Re: **Report Transmittal
Work Plan – Site Assessment
76 Service Station #4186
1771 First Street
Livermore, CA**

Re: Revised Work Plan – Agency Response and Further Site Characterization Activity
ATC Project No. 75.75118.1237
76 Service Station No. 4186 / COP No. WNO 1237
1771 First Street
Livermore, California

| DESIGNED | DRAWN BY: EC | PROJECT NO. 75.75118.1237 | FIGURE 2 |

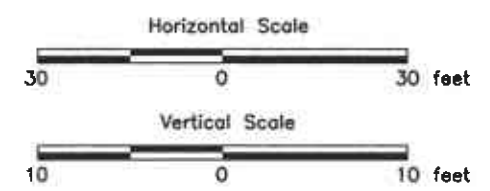
The Alameda County Health Care Services (ACHCS) has expressed concern that the lateral extent of contamination within a sand-gravel layer has not been adequately defined. A cross section has been

ATC concurs that additional monitor wells are necessary in the vicinity of U-2 and U-3. Proposed wells (new U-10 near existing U-2, and new U-9 near existing U-3) are depicted on the cross section, **Figure 2**, and the site map, **Figure 3**. Well screens will be placed in the lower coarse-grained unit from approximately 32 to 40 feet bgs. The cross section also depicts an additional proposed monitor well, previously described in ATC's May 23, 2005 *Work Plan – Site Assessment* document.

prepared, **Figure 2**, depicting the lithology, hydrology and well network perpendicular to the direction of groundwater flow across the site. **Figure 3** depicts the site in plan view with the cross section line and associated proposed monitor wells further described herein. The cross section characterizes the subsurface lithology utilizing wells logs prepared by various individuals over time. ATC concurs with your comments describing the lateral delineation deficiencies with the exception of the area surrounding offsite monitor well U-5. Note that this well is installed to approximately 45 feet below ground surface (bgs) within the lower clay-sand sand-gravel transition unit observed from approximately 40 to 45 feet bgs. U-5 is screened within the lower coarse-grained lithologic unit where groundwater was detected at approximately 40 feet bgs during drilling. This unit is bounded by low permeability clays, the upper clay representing an aquitard separating the initial water bearing unit observed at approximately 20 feet bgs. U-5 appears to be cased sufficiently to characterize the second water-bearing unit observed at 40 feet bgs.

TYPICAL MONITOR WELL DIAGRAM

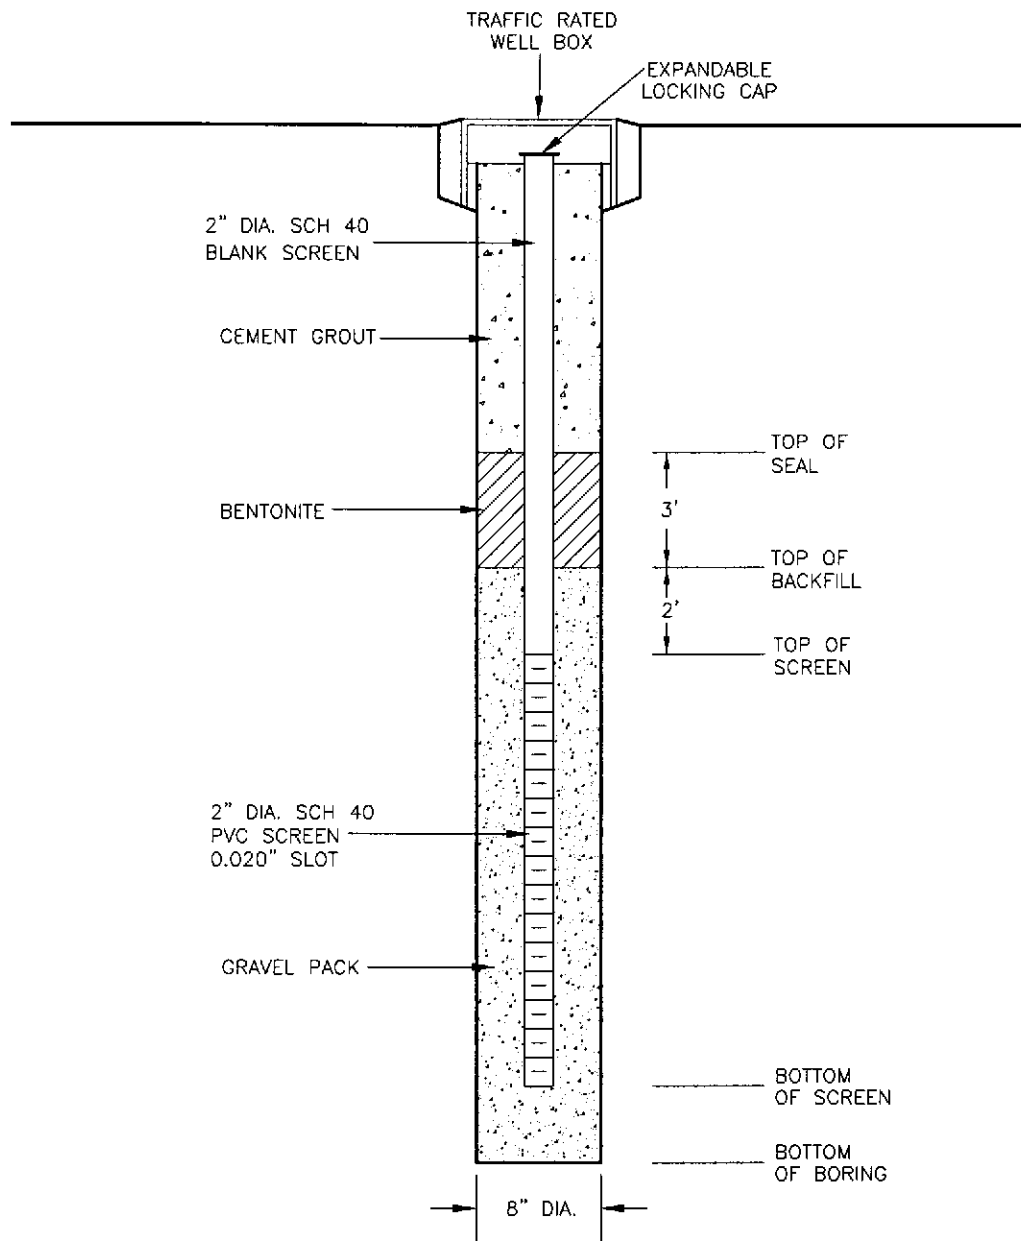
5. **Proposed Upgradient Monitoring Well.** The "Proposed Scope of Work," on Page 3 of the Work Plan indicates that one monitoring well will be installed to a depth of approximately 45 feet below ground surface (bgs). In contrast, the "Monitor Well Installation and Soil Sampling Procedures," on Page 4 indicates that the well screen will extend from approximately 25 to 35 feet bgs. Please clarify using a cross section in the Revised Work Plan requested below, the proposed target interval for the proposed upgradient well.

The screen interval described in ATC's May 23, 2005 *Work Plan – Site Assessment* for proposed upgradient monitor well U-8 was a typo and should have read "from approximately 35 to 45 feet bgs". Revised well construction descriptions are detailed in the section titled "Monitor Well Installation and Soil Sampling Procedures" in Part 2.

Three proposed monitor wells described in Part 1 will be installed to approximately 40 to 45 feet bgs, depending on subsurface lithologic features. Monitor well U-11 and U-12, two nested-pair monitor wells, will be installed at 25 feet to 45 feet bgs, each with a 10 foot screen. Each well will be constructed using 2-inch diameter polyvinyl chloride (PVC) well casing and screen (0.020-slot) and will be designed based upon field conditions observed while drilling. The well construction details will consist of well screen from approximately 35 to 45 feet bgs and well casing from 0 to 35 feet bgs. The exact intervals and screen length will be dependent upon observed aquifer and hydrocarbon impact conditions. The wells will be completed such that the lower coarse-grained unit will be isolated with well screen; this will allow a more adequate representation of dissolved hydrocarbons and aquifer characteristics of the lower coarse-grained unit. The sand pack will consist of #2/12 Monterey sand; the well will be sealed with hydrated bentonite chips and Portland cement. The wells will be set to grade and the well head covered with a traffic-rated vault box. **Figure 4** depicts a typical monitor well construction diagram. A detailed
